## Sports & Exhibition Authority

Addendum # 1- Internet Services

March 11, 2025

**AGENDA**  
**Internet Services at the David L. Lawrence Convention Center**  
**Non-Mandatory Pre-Proposal Meeting**  
**Monday February 24, 2025**  
**11:00 AM**

## LEVEL THREE

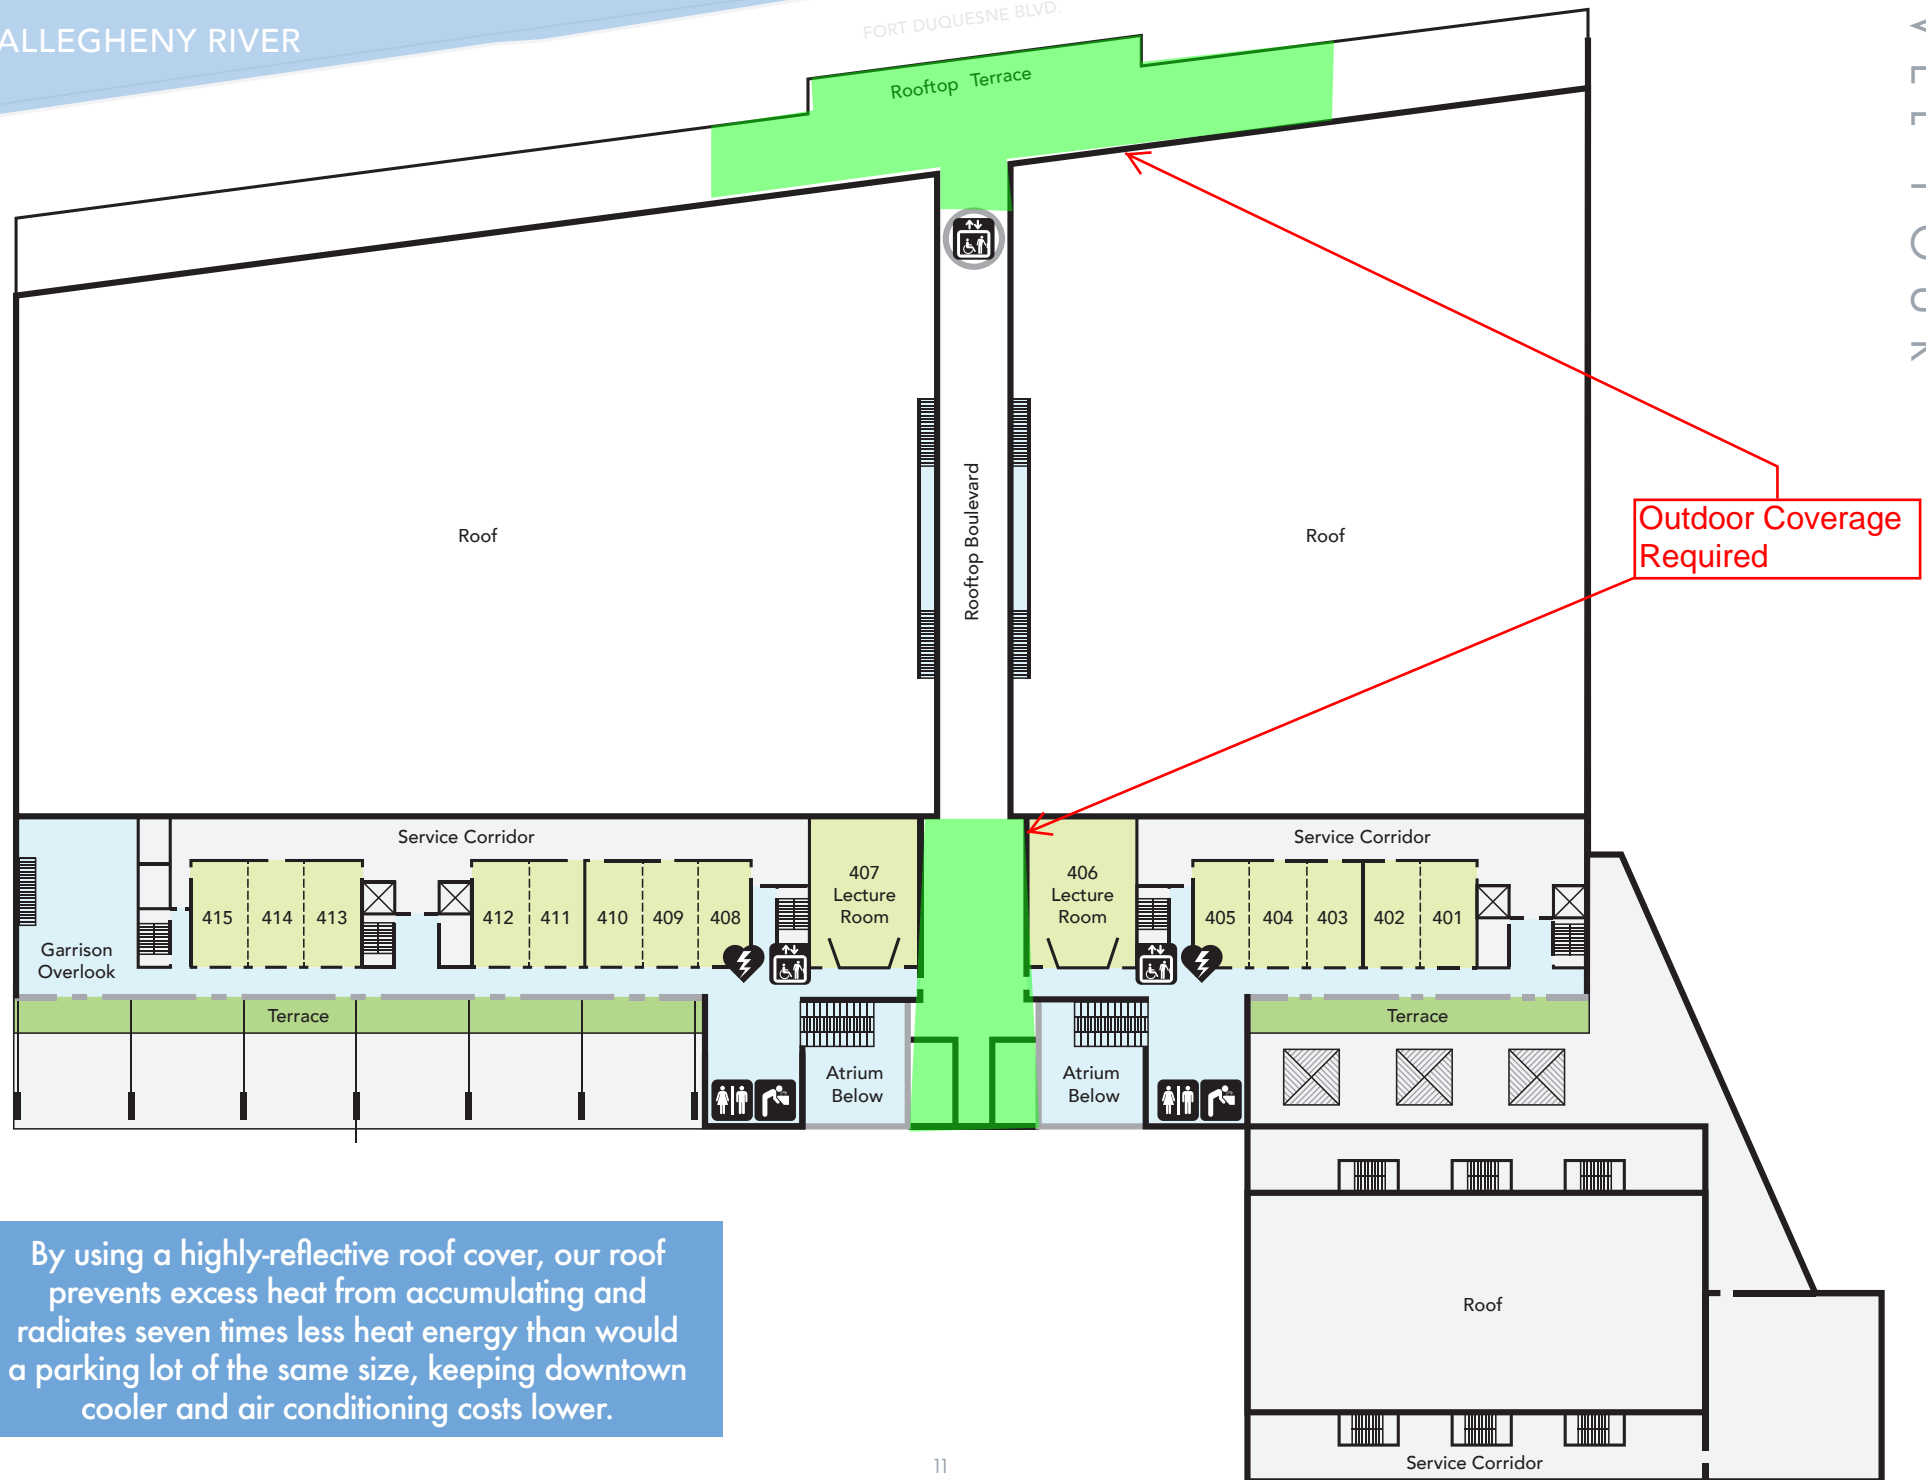
- i. Proposers are encouraged to conduct a site visit to field verify current locations.*
- v. Can you please clarify where the outdoor coverage is required – is this new coverage or enhancement upon existing coverage?

Outdoor Coverage Required

- i. See markings on attached floor plans for details; this is existing coverage*
- w. Can you break it down to expected outside area to cover in square feet?

- i. Outdoor coverage should reflect at a minimum the coverage provided in the attached floor plans; additional areas of coverage can be proposed as value-added areas. Event specific coverage enhancements would fall into the value-add category.*
